Local Planning Panel

7 Rennie Street, Redfern

D/2024/69

alterations and additions to existing residential terrace, including a first-floor rear addition accommodating a new bedroom, study and bathroom

Floor space ratio

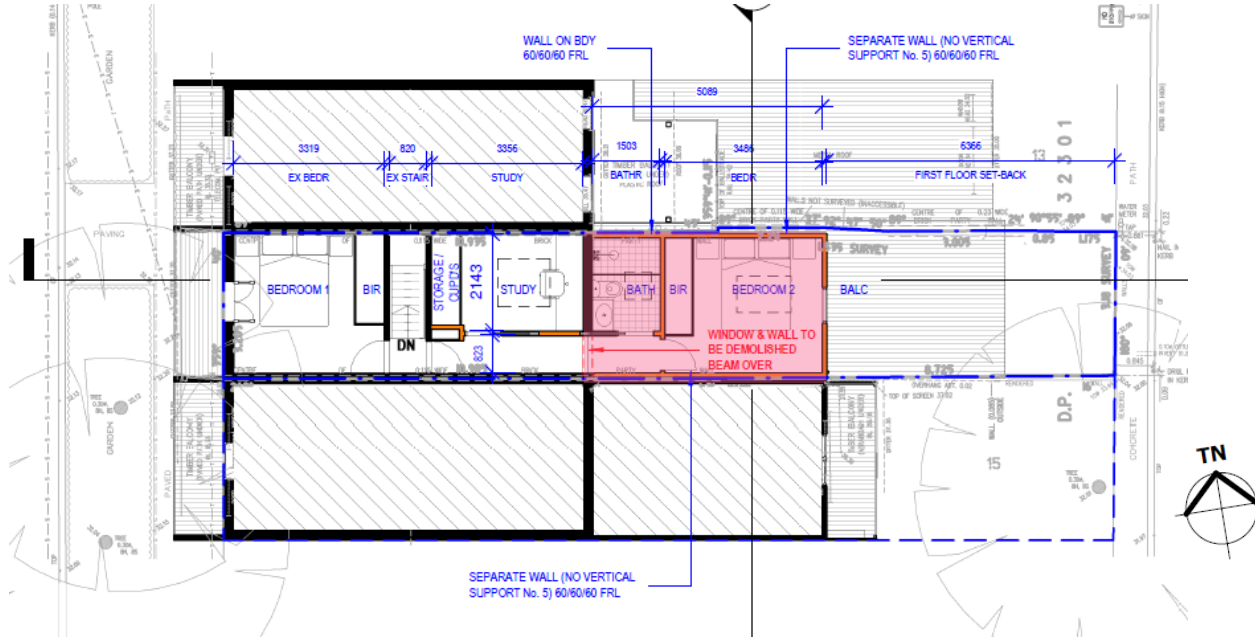
- non-compliance with 1:1 FSR control, proposed FSR 1.43:1
- existing non-compliance of FSR 0.16:1 (existing exceedance of 10.1sqm)
- proposed additional FSR 0.27:1 (GFA of 17.1sqm)
- clause 4.6 variation request supported
- no significant adverse overshadowing, heritage, privacy, views or other environmental impacts arising from non-compliance

Rear setback

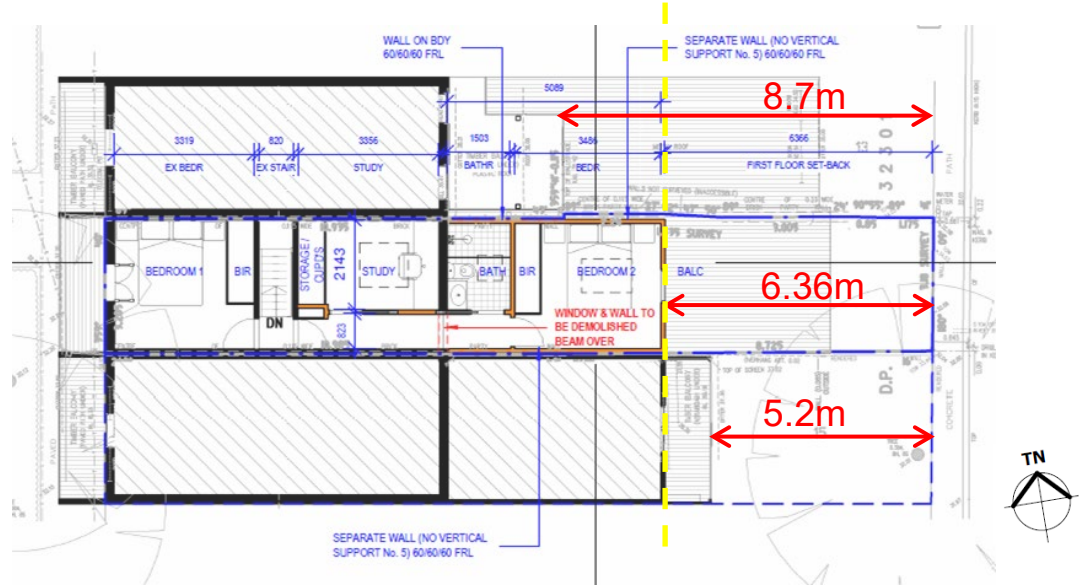
- existing terrace row does not have a consistent rear setback at ground or first floor levels
- existing first floor rear setback of:
 - 4.3m to 8.5m provided to Nos. 1, 3 and 5 Rennie Street
 - 5.2m to Nos. 9 and 11 Rennie Street (to external face of balconies)
- proposal is commensurate with existing development pattern of southern terraces

inconsistent first floor rear setback
proposed addition aligns with Nos. 9 and 11 Rennie Street

proposed shadow diagrams

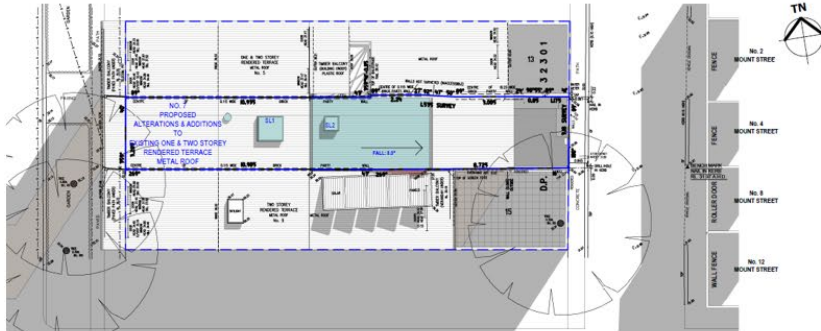
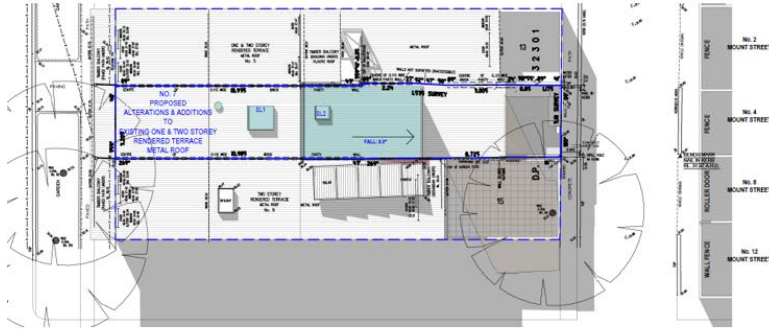
- overall negligible overshadowing impacts resulting from proposal
- existing site and neighbouring dwellings do not receive min. 2 hours during mid-winter to open space or living room windows
- proposal complies with DCP - does not result in additional shadows to open space or living room windows to site or neighbouring dwellings
- maintains existing direct sunlight of 1 hour to 8sqm of open space to 9 Rennie Street between 11.00am to 12.00pm
